**SOLICITATION E0208-150548/A - AMENDMENT No. 5 APPLYING ADDENDUM No. 3**

Public Works and Government Services Canada	Swift Current, SK AAFC Semiarid Prairie Agricultural Research Centre (SPARC) Rehabilitation	Addendum No. 3 Page 1 of 12
Project No.: R.036324.001		January 22, 2015

**ADDENDUM NO. 03**

**MV103R1**

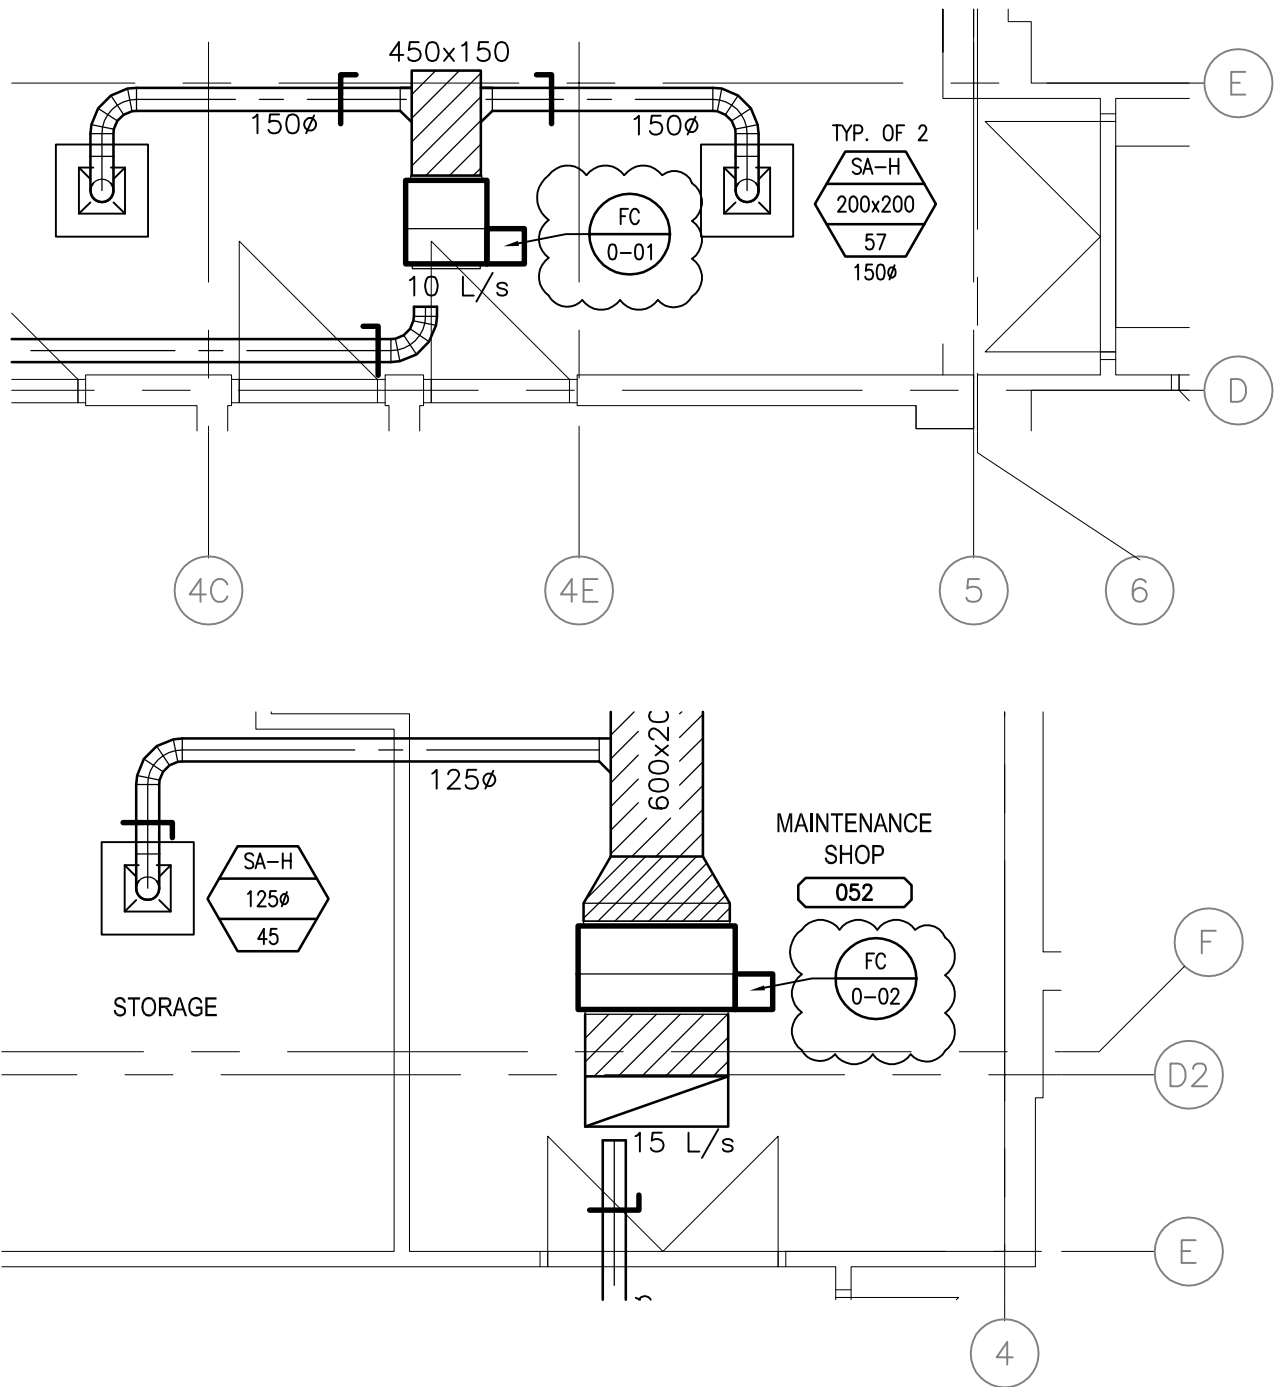
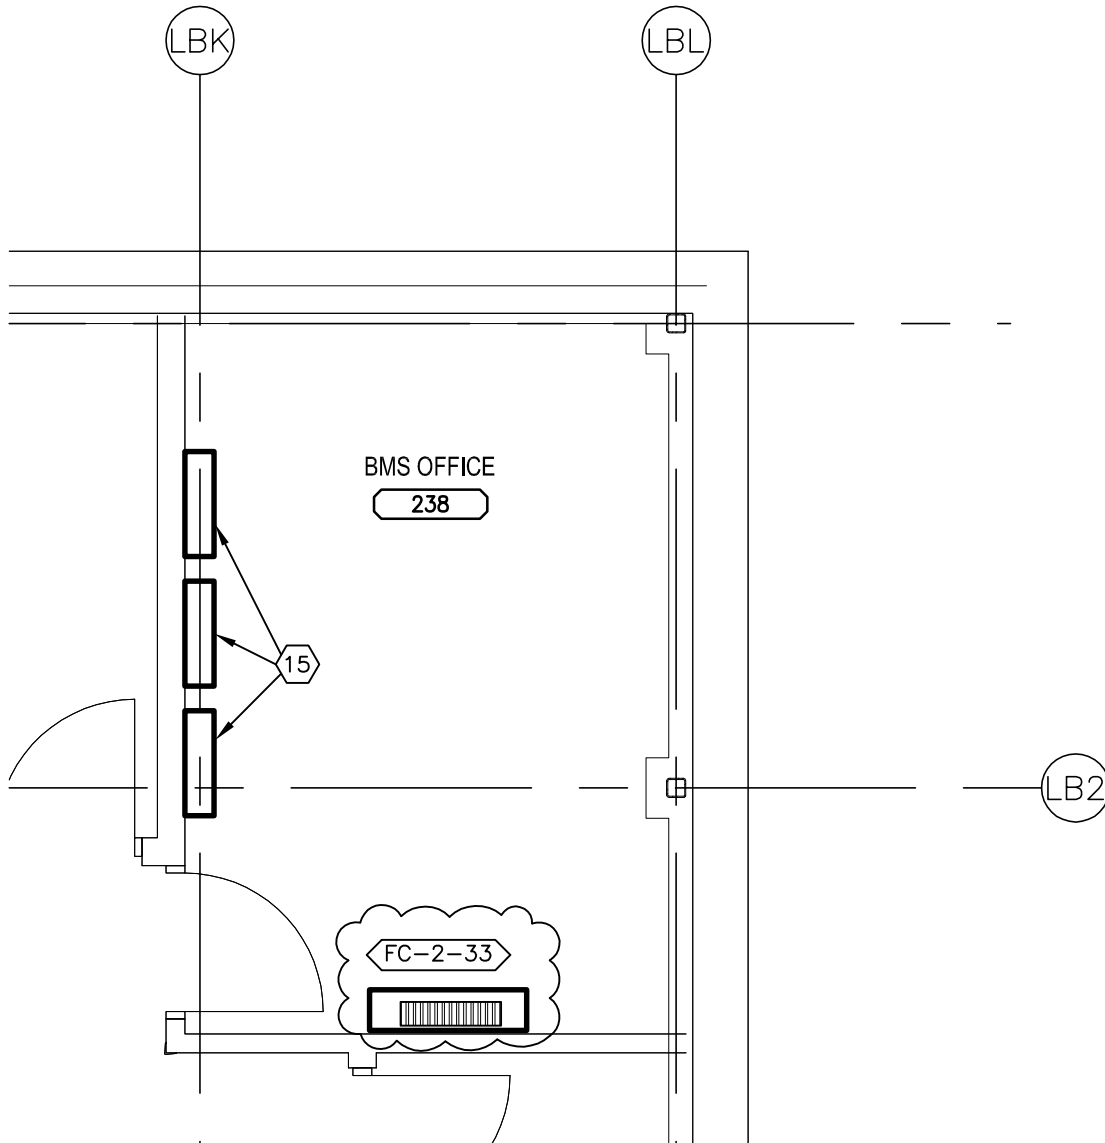
- .1 Add 2 fancoil units, FC 0-8 and FC 0-9 to mechanical equipment room 051 as indicated on the attached revision sheet MV103R1.
- .2 The fancoil identified as FC 0-11 should be tagged FC 0-02. Revise fancoil tag as indicated on the attached revision sheet MV103R2.
- .3 The fancoil identified as FC 0-12 should be tagged FC 0-01. Revise fancoil tag as indicated on the attached revision sheet MV103R2.
- .4 Add fancoil unit, FC-0-07, to Engineer Office. Refer to drawing MH103 for location.

**MV121R1**

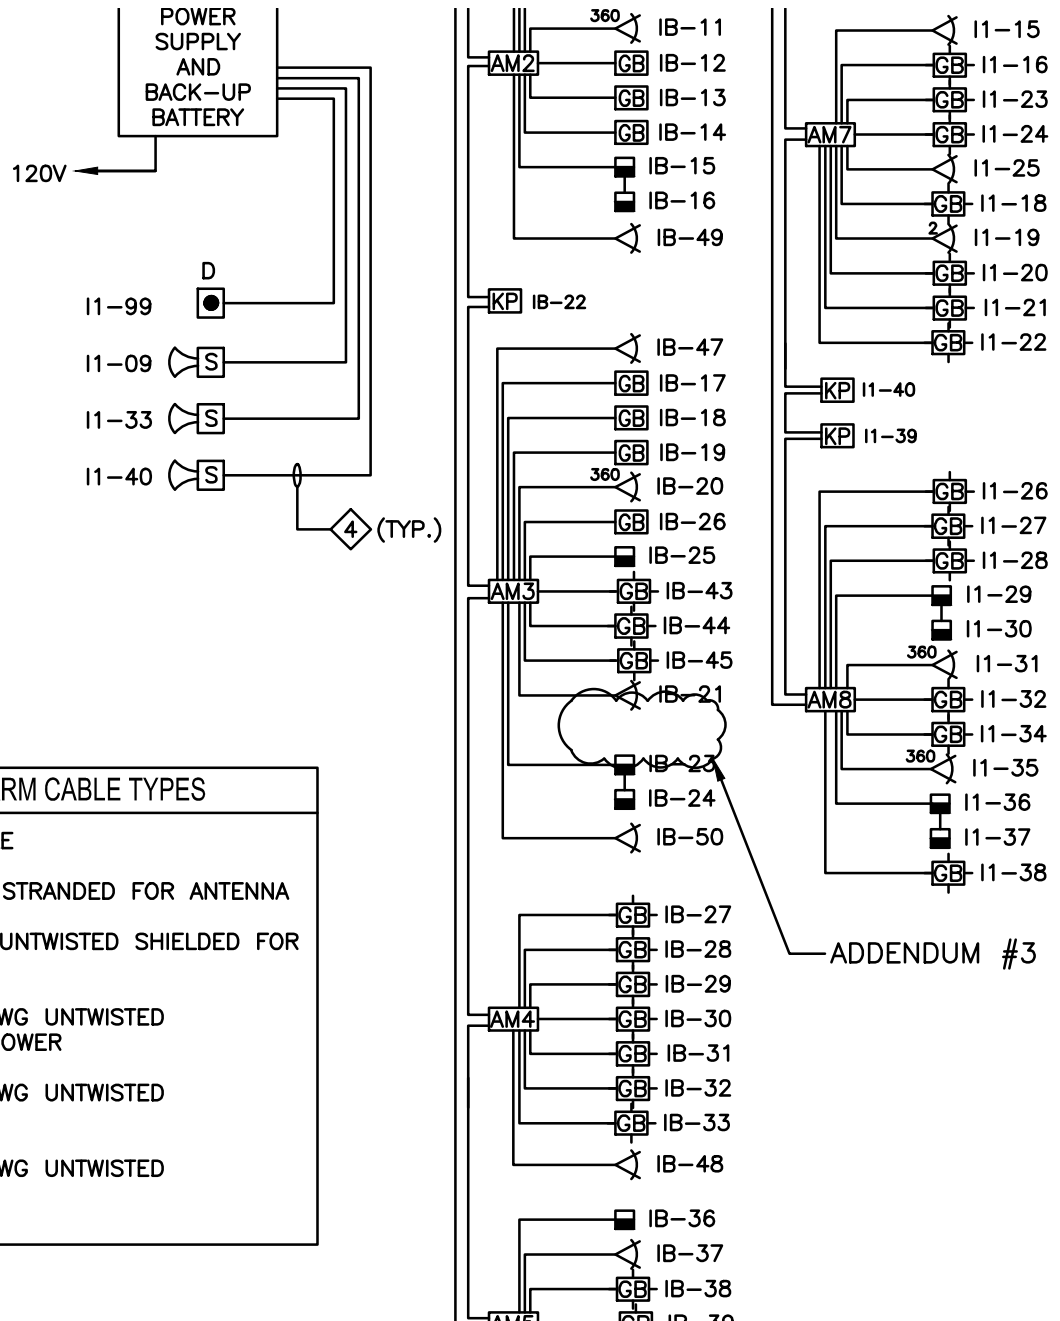
- .1 The fancoil located in BMS Office 238 is to be tagged as FC-2-33. Refer to the attached revision sheet MV121R1.

**TG601R2**

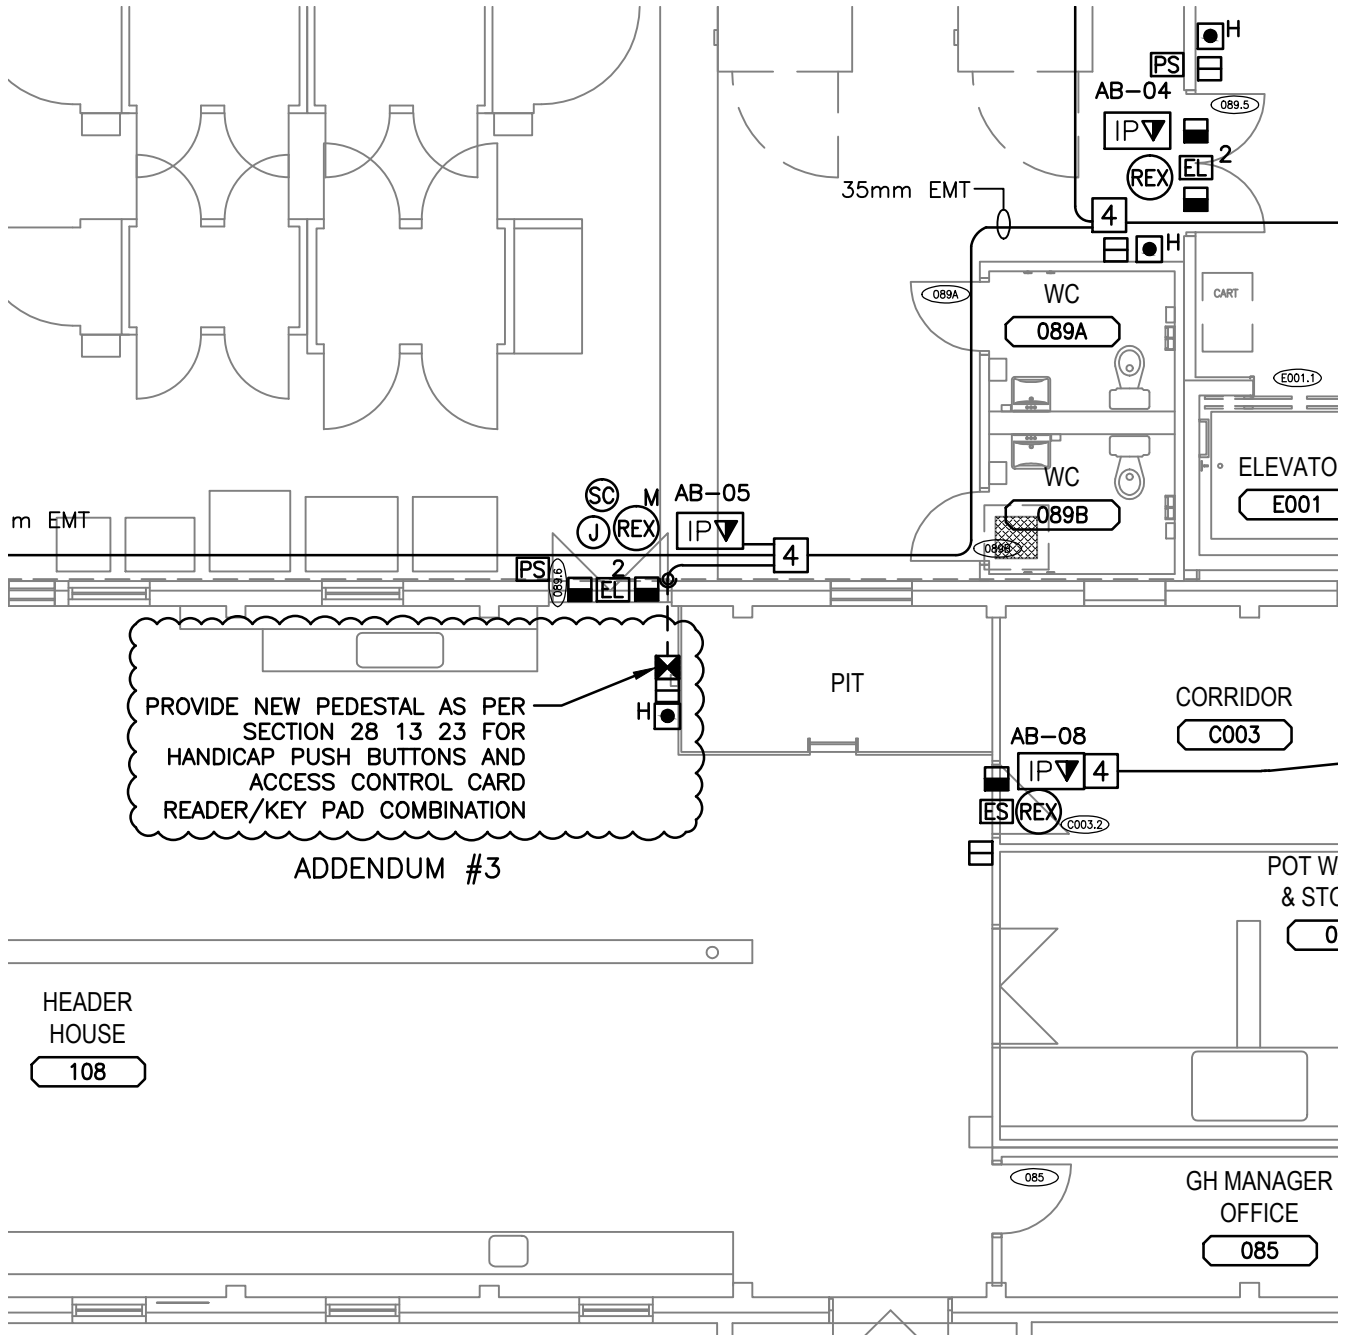
- .1 Delete glass break sensor designated as IB-46 as indicated in part plan drawing TG601R1.
- .2 Clarification: The hexagon symbol indicate in the door details are for access control cable types and conduit types. Refer to part plan drawing TG601R2.

TN100R11:100

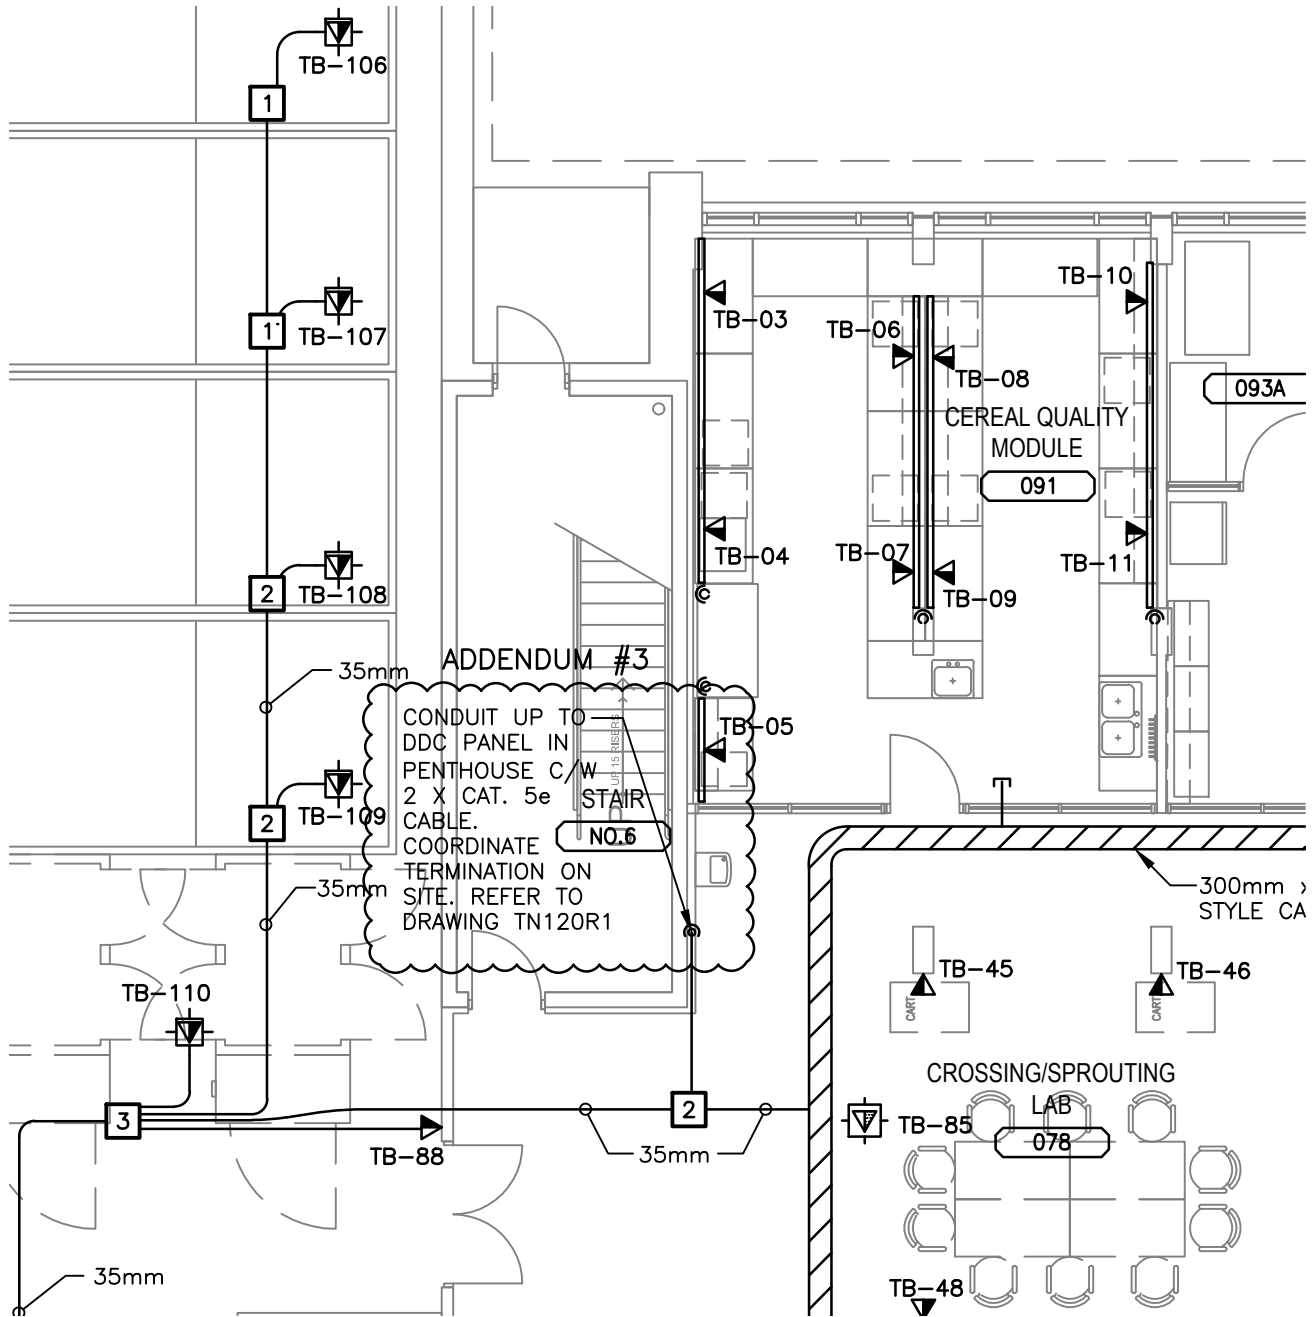
- .1 Clarification: 35mm Rigid PVC conduit to be installed in the existing Salinity Green House 75C. Refer to part plan drawing TN100R1.

## BASEMENT TELECOMMUNICATIONS PLAN

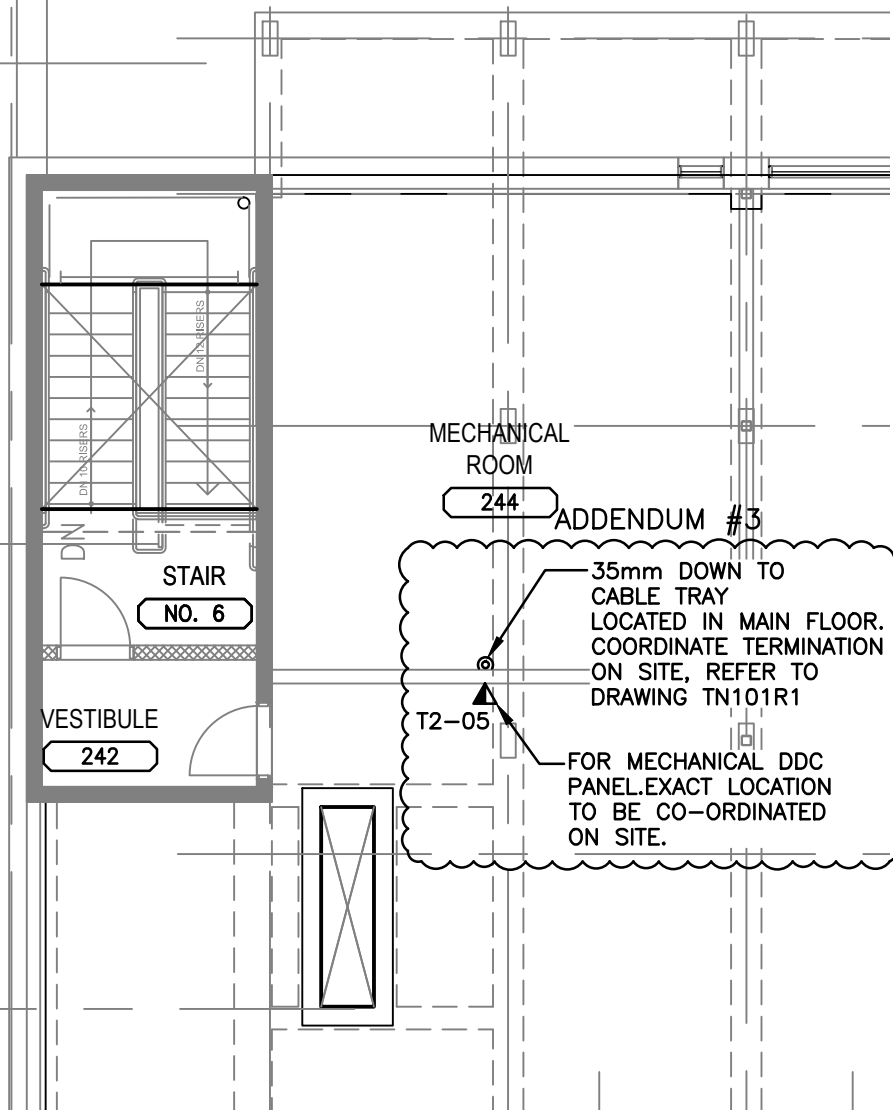
- .1 Clarification: Conduit to be installed up to Penthouse. Refer to part plan drawing TN101R1.
